Request for Class II Permissive Change

FCC ID: 2ARF9CSG-BT
Date of Grant: 10/08/2019

FCC- C2PC-Cover Letter

Original

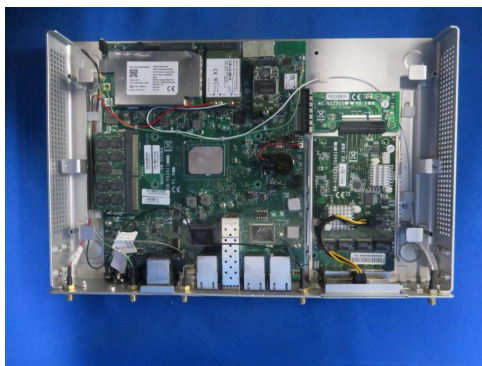
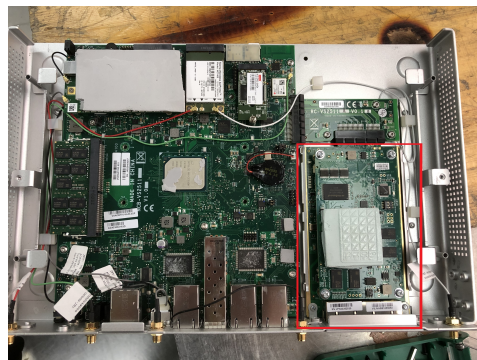
1. Versa Cloud Services Gateway CSG700 series provide one slot for optional Network Interface Card (NIC). CSG700 series already including a NIC-4GP card to provide 4 ports electrical GE interface and support 802.3at POE. Versa Networks also develop several kinds of new NIC to replace the NIC-4GP card for different customer deployments as below:

- NIC-4GP-120W
 - NIC-4GP-120W provide 4 ports electrical GE interface, and support 803.3bt PoE, single port supports up to 60W, and total 4 ports support up to 120W.
- NIC-4GF
 - NIC-4GF provide 4 ports optical SFP GE interface.
- NIC-8GE
 - NIC-8GE provide 8 ports electrical GE interface.
- NIC-4DS
 - NIC-4DS provide 4 ports T1 interface.

2. The RF part of the product is exactly the same, but the NIC is different.
